SALTON SEA UNIT 6

CURE DATA REQUESTS SET THREE (# 237 – 275)

AIR QUALITY

Table 2 AFC's Wind Speed Correction Factors

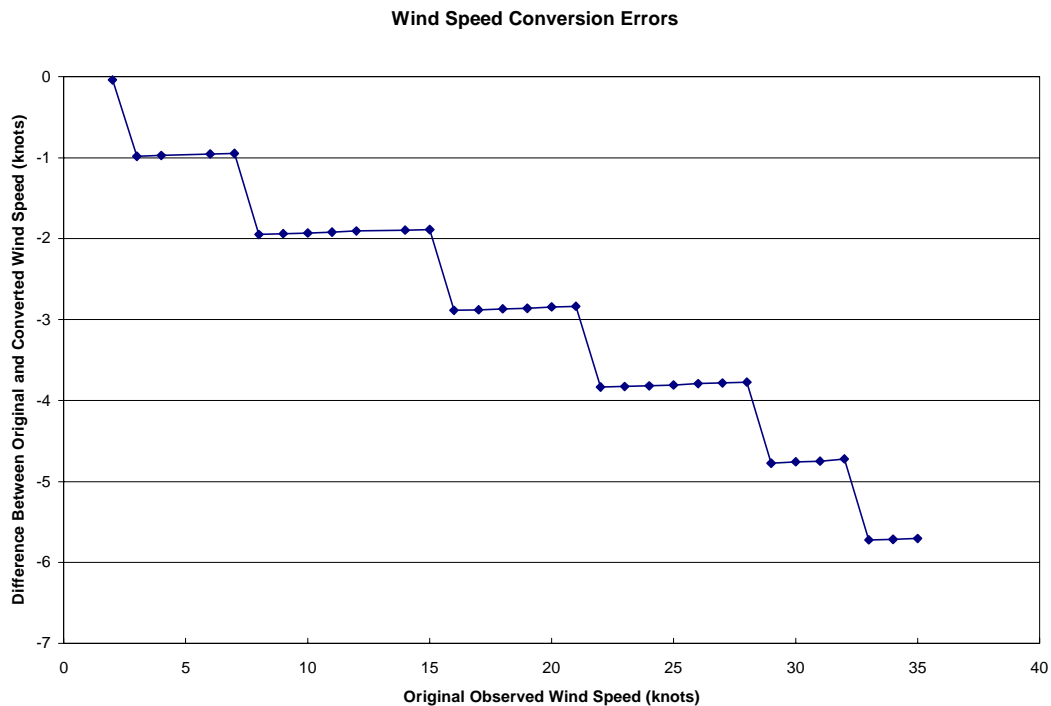
Clearly, the conversion factor should be the same regardless of wind speed. The peculiarity in the AFC's processed meteorological data seems to result from some sort of a "correction" factor that varies with wind speed as shown in Table 2, and graphically in the following figure.

When the correction factor is applied to the original wind speed observation, all of the AFC's processed wind speeds reflect the correct conversion factor from knots to m/s of 0.5444. It is unclear as to why the wind speeds have been altered prior to converting from knots to m/s, but it is clearly incorrect. Therefore, at a minimum, the meteorological data would need to be reprocessed to reflect observed conditions, as originally measured.
